## TRACTOR SERVICE INFO

TB1666

### Part Nr. 230 0009 11 – 300/280mm TGU6

**SDF DX110A**  
**DX85A**  
**DX90**

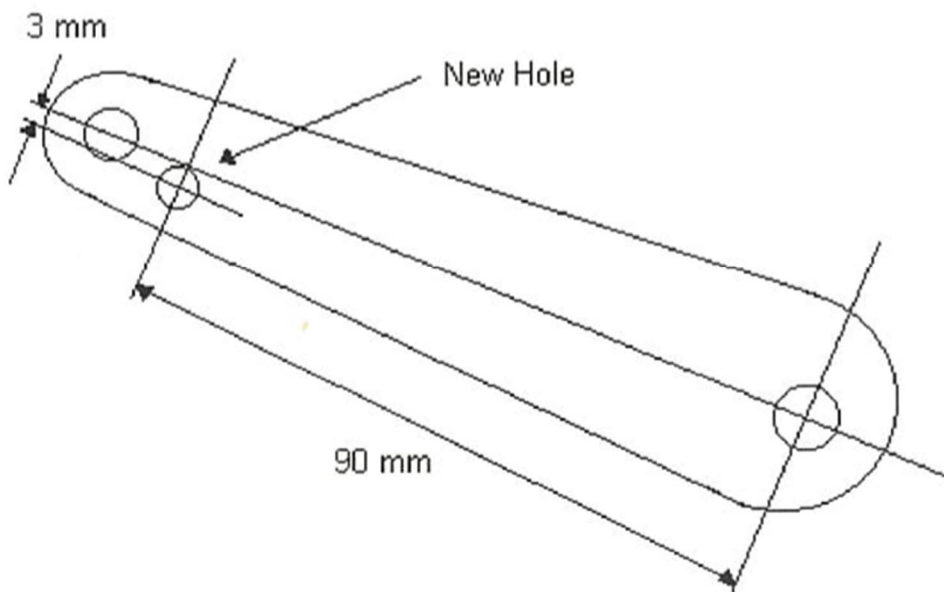
If you replace the earlier type clutch with the later model, then it is necessary to modify the release bearing movement sufficiently to ensure full disengagement. Failure to make this modification will cause severe clutch drag.

Der Hintergrund dazu ist, dass die ersten DX für die Fahrscheibe keine Belagfederung hatten. Dadurch war natürlich bedingt durch den Sinterbelag, das Anfahrverhalten sehr gewöhnungsbedürftig. Das wurde geändert und eine Belagfederung eingebaut. Mit der Belagfederung wird aber mehr Ausrückweg benötigt. Diesen zusätzlichen Ausrückweg bekommt man durch die zurückgesetzte Bohrung. Die Bohrung wird in den angeschweißten Hebel der Ausrückwelle gebohrt. Siehe Bild.

- Drill a new hole in the cross-shaft bellcrank arm ( dia 12.3mm ) in the position shown below.
- The clutch pedal travel must be increased from 180mm to 206mm by modifying the stop screw ( Note: it may be necessary to shorten and re-thread the pull rod accordingly ).
